Detailed Site Plan Marlboro Gateway

DSP-22019

STAFF REPORT

SUBJECT: Detailed Site Plan DSP-22019
 Type 2 Tree Conservation Plan TCP2-046-2022
 Marlboro Gateway

Figure 1: Site Plan

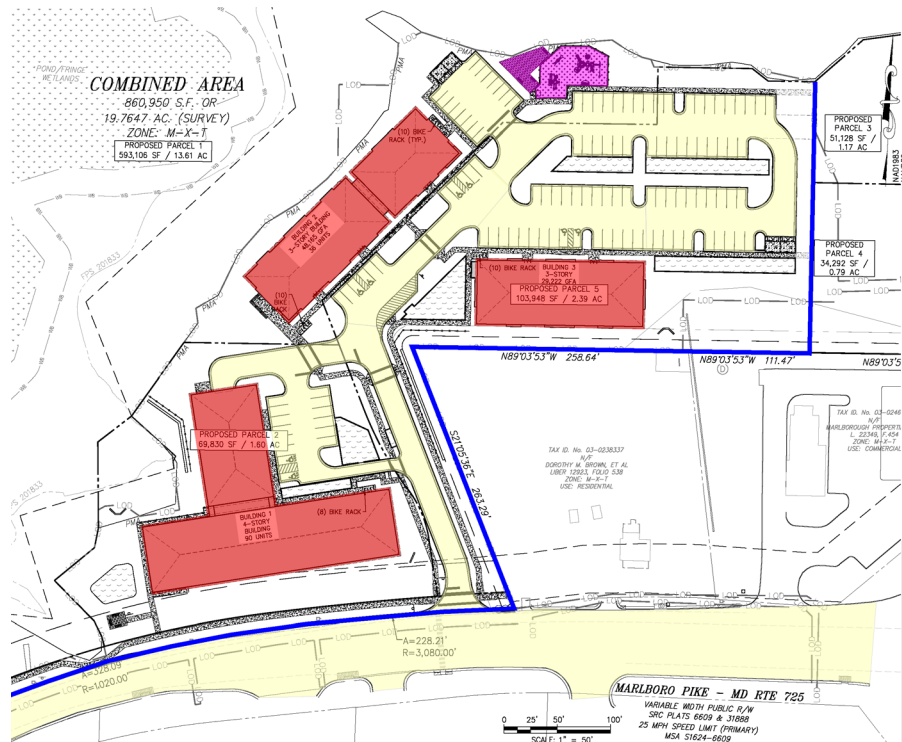
The site plan shows three retaining walls located near Buildings 1 and 2 to accommodate the steep topography of the site. These walls vary from 2 to 19.6 feet in height and are proposed to be constructed of modular concrete blocks. However, the detail for these retaining walls does not specify the color of the concrete blocks. A condition has been included herein, requiring that the color of the retaining wall blocks match the color of the masonry brick used in the buildings.

The detailed plan of the tot lot depicts engineered wood fiber as the surfacing of the play area. However, the cost estimate provided on the coversheet lists rubber surfacing. Staff finds that rubber surfacing is safer, more durable, and more desirable than engineered wood fiber surfacing. Therefore, the details shall be revised to specify rubber surfacing for the play area, prior to signature approval of the DSP.

The DSP also includes details for trash receptacles. The site plan, however, does not indicate the location(s) where these trash receptacles will be provided. At a minimum, trash receptacles should be provided near the picnic tables and the play area, and along the pedestrian paths close to building entrances.

The DSP proposes two seating areas for passive recreation. A small seating area, approximately 220 square feet in area, is proposed between Building 1 and MD 725. This seating area is accessible via a pedestrian path from both Building 1 and the public sidewalk fronting MD 725. Dense planting of evergreen and shade trees is proposed to shelter this seating area from the public street. However, this area is subject to nuisance noise levels due to proximity to MD 725 and should be removed. A second, larger seating area of approximately 930 square feet is proposed near the play area. This seating area provides seating benches and picnic tables. The surface of this seating area is proposed to be permeable pavement for which a detail has been provided in the DSP. The permeable pavement appears to be constructed of open pavers, which could be of concern for not being ADA-compliant. A note shall be added to the detail of permeable pavement, stating that the surface will be ADA-compliant. The site plan should also be revised to provide a detail for the proposed picnic tables.
